# **ADDENDUM NO. 1**

## **VILLAGE OF COVINGTON Wastewater Treatment Plant Improvements Phase II Blower Replacement February 13, 2019**

EXISTING EXHAUST FAN PICTURES

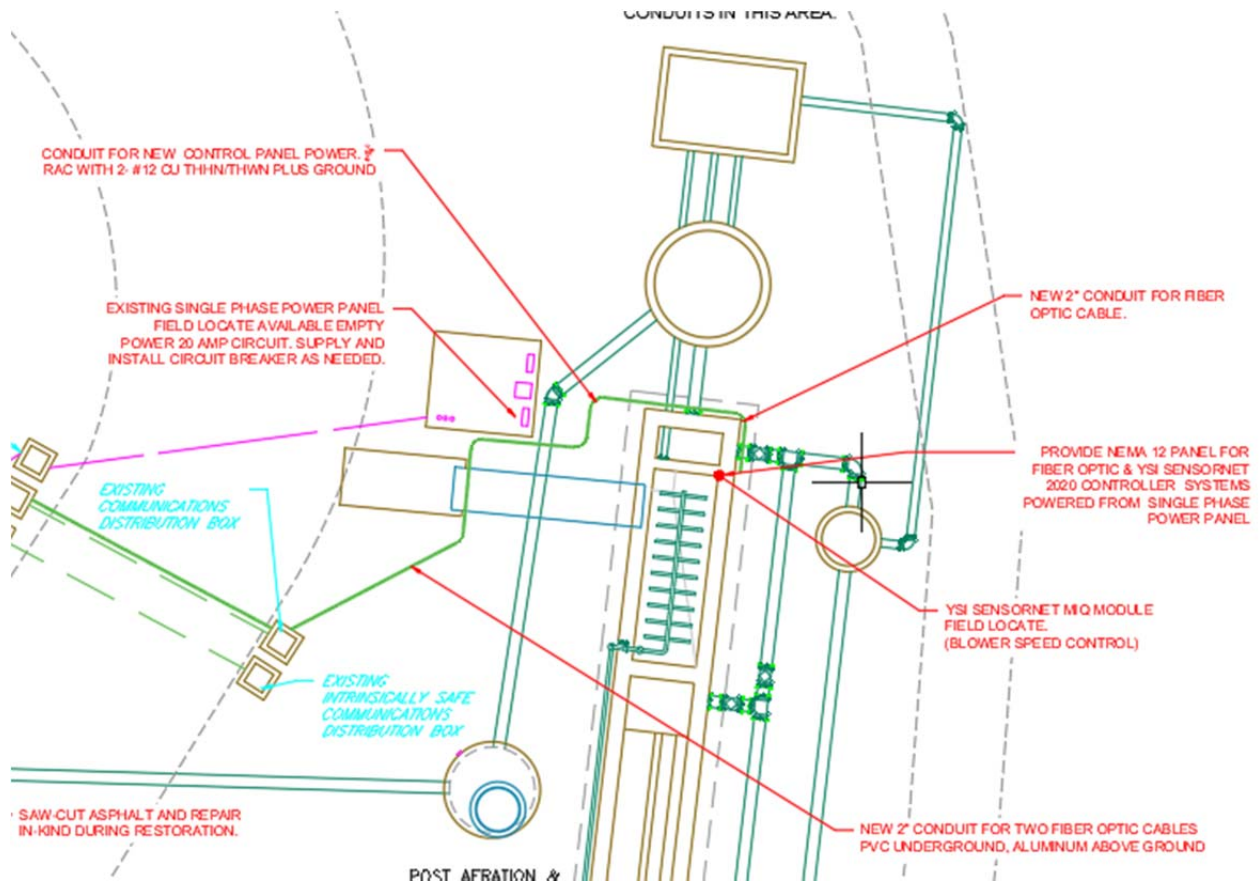
- a. The nomenclature tags and/or identification markings on the existing exhaust fan are missing. Contractors may inspect the ventilation fan during the Pre-Bid Meeting to confirm type and size. Photos of the existing fan are attached to this Addendum. The replacement fan shall be of a similar type and mounting configuration with a new thermostat that is speed controlled. The new exhaust fan shall meet or exceed the following standards: Twin City Fans, with efficiency motor, Model #DCRU093B or equal. (Brock Air Products, Troy, Ohio)
